Store #12208
Approved with Changes
6-6-08
Richard Steighner

revised STORE

#12208 SCHEMATIC

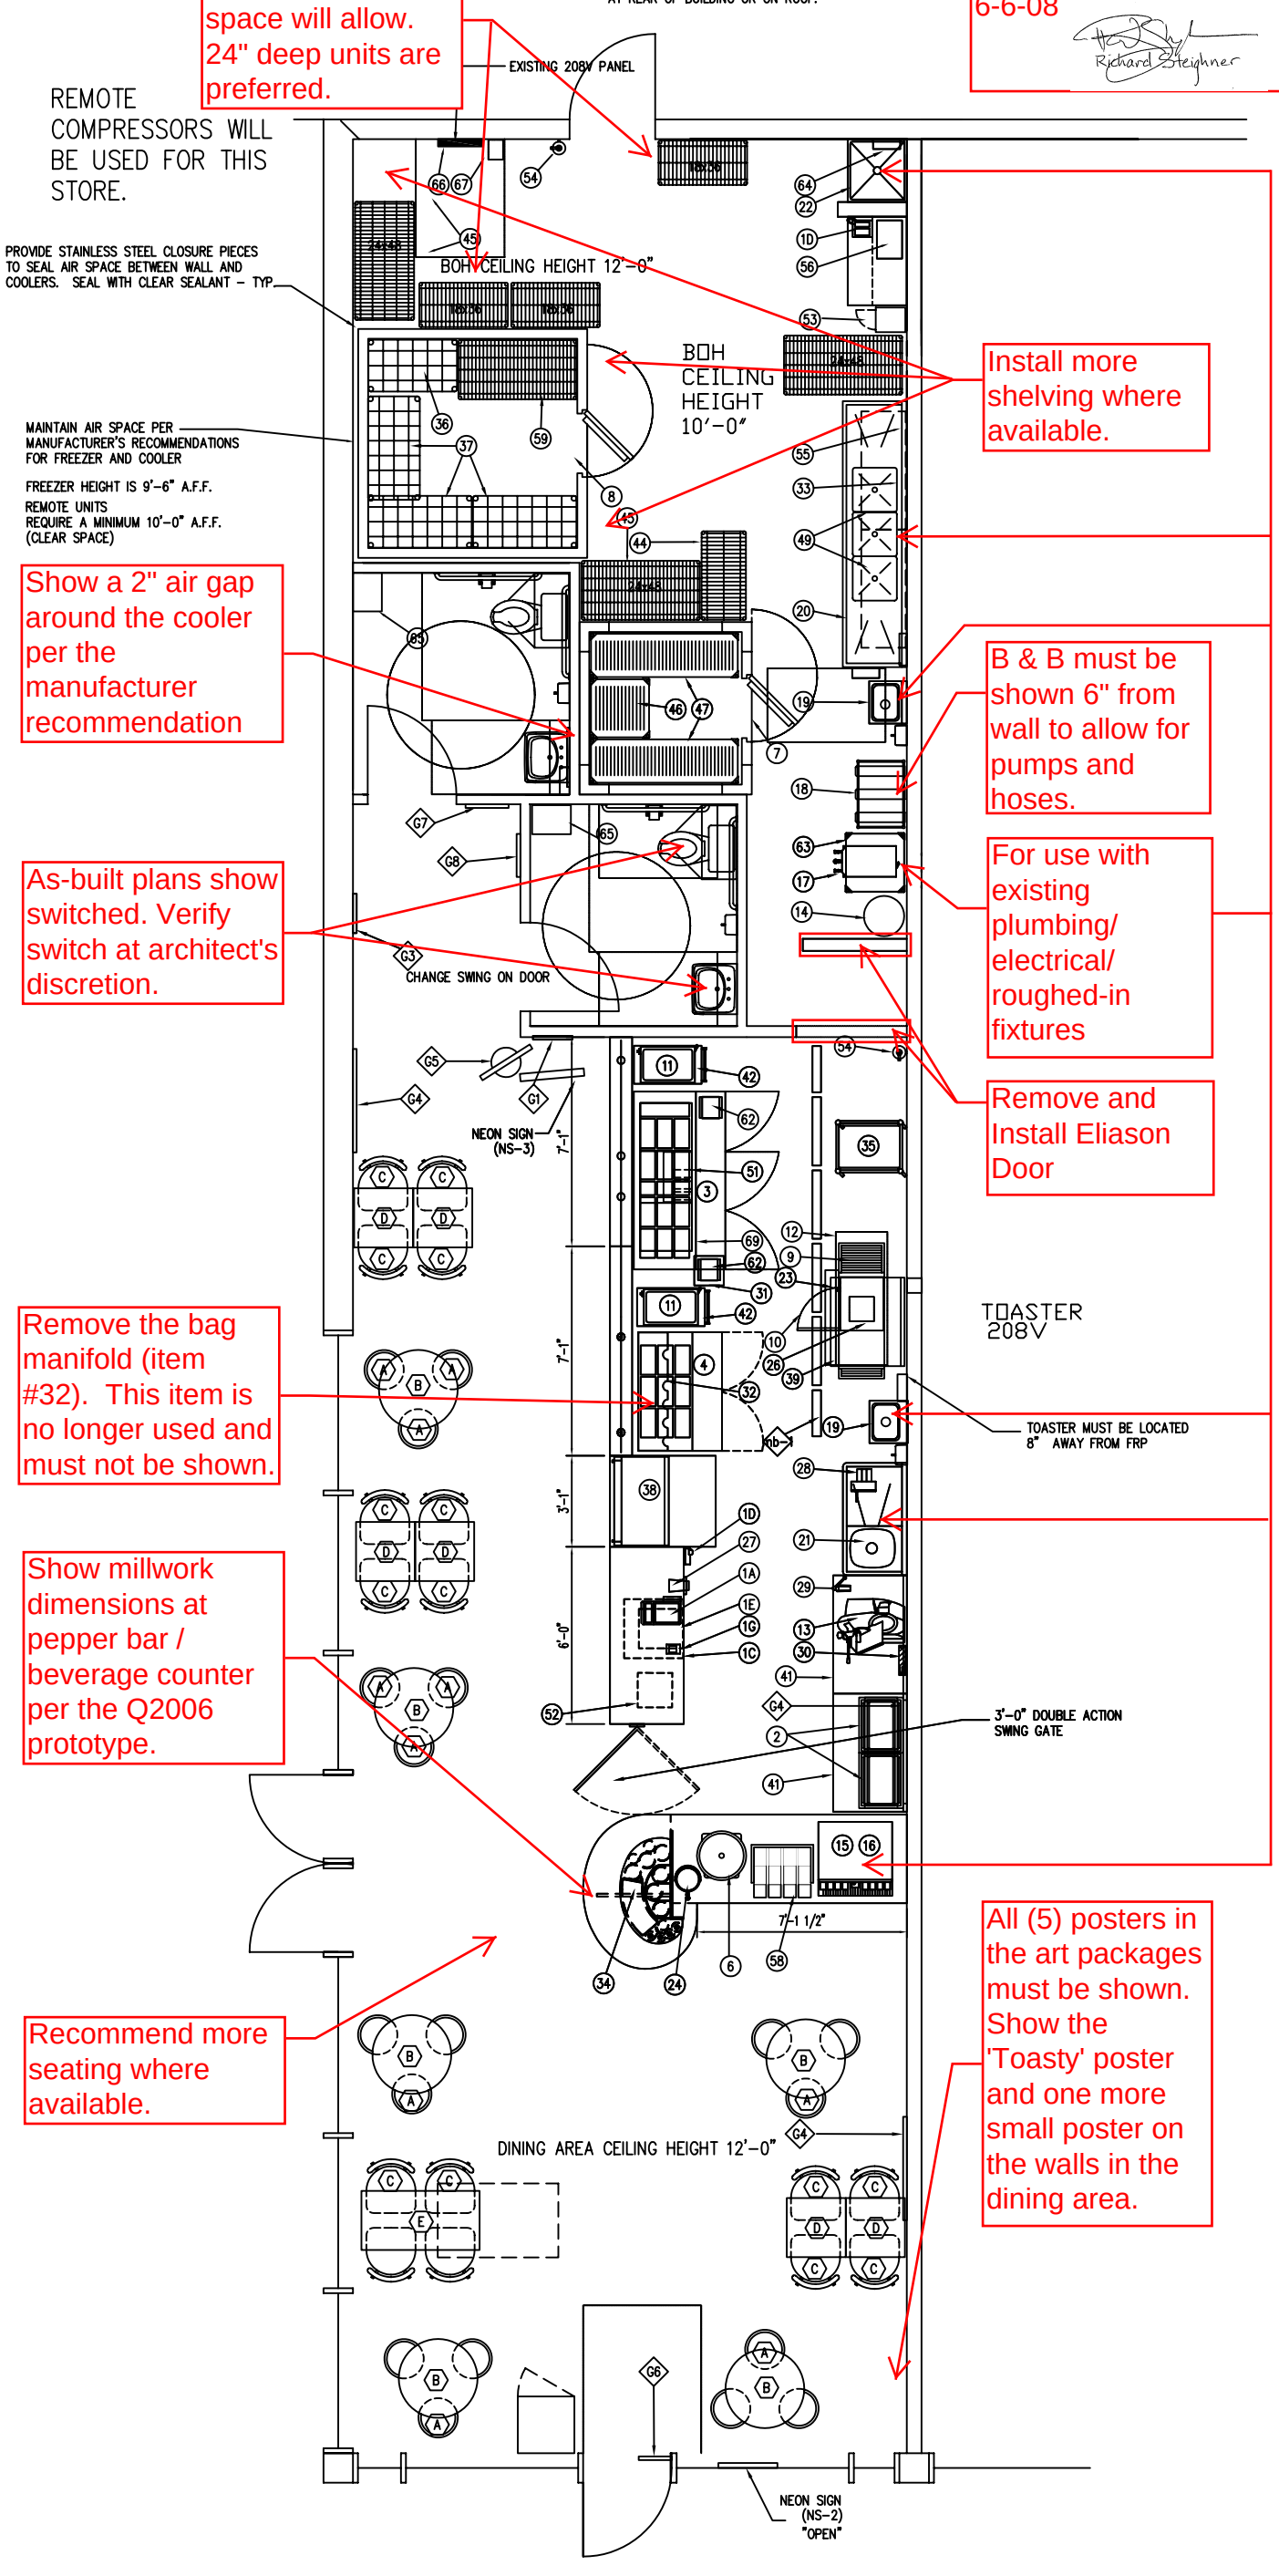
Show largest shelving units space will allow. 24" deep units are preferred.

Install more shelving where available.

Show a 2" air gap around the cooler per the manufacturer recommendation

B & B must be shown 6" from wall to allow for pumps and hoses.

As-built plans show switched. Verify switch at architect's discretion.

Remove and Install Eliason Door

Remove the bag manifold (item #32). This item is no longer used and must not be shown.

Show millwork dimensions at pepper bar / beverage counter per the Q2006 prototype.

Recommend more seating where available.

All (5) posters in the art packages must be shown. Show the 'Toasty' poster and one more small poster on the walls in the dining area.
